MODIFIED 3/17/2004 8:46 AM	Author	Page	Total
EED Department	ORIGINATOR	@Designer_1	DATE @Designer_2
	DRAWN	@Designer_3	DATE @Designer_4
	CHECKED	@Designer_5	DATE @Designer_6
	APPROVED	@Designer_7	DATE @Designer_8
<div> <b>Fermi National Accelerator Laboratory</b> United States Department of Energy</div> <div>D:\CCM\ccm_board5_v4_6U\ccm_board5_v4_6U.prj</div>			
SIZE D	DRAWING NUMBER @Designer_9	Schematic Page 02 of 03	REV @Designer_10

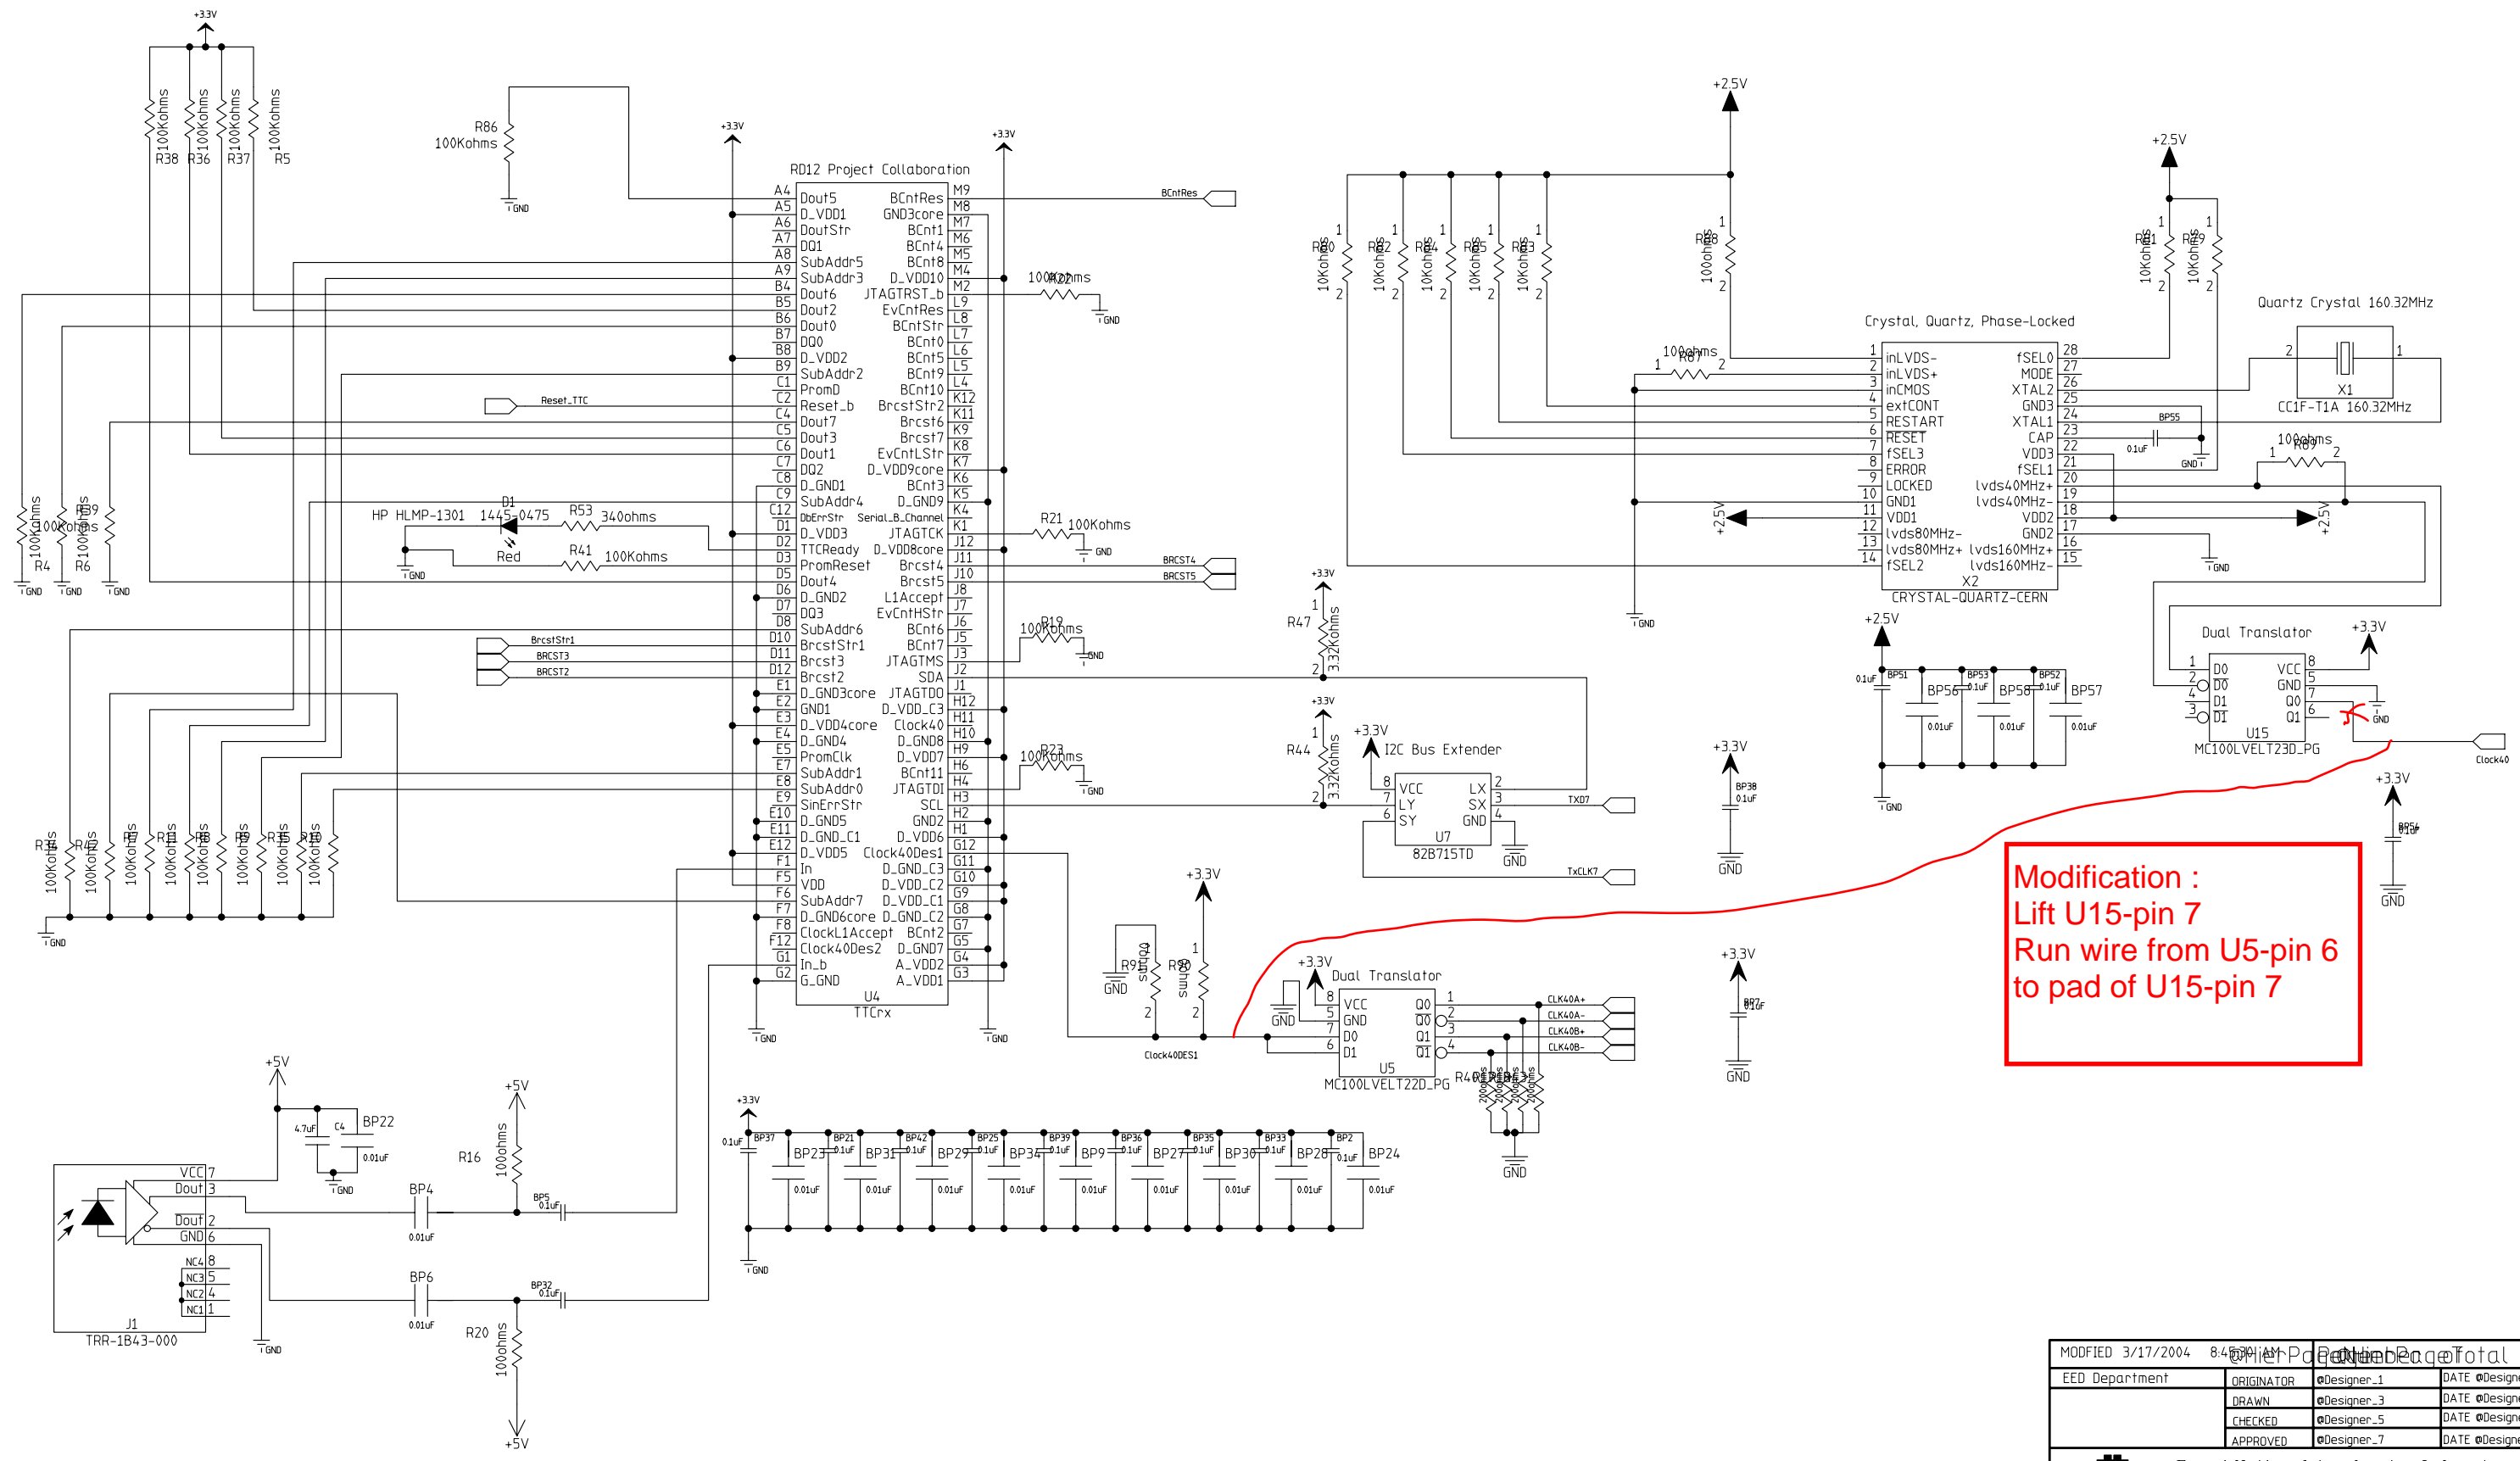
Modification :  
Lift U15-pin 7  
Run wire from U5-pin 6  
to pad of U15-pin 7
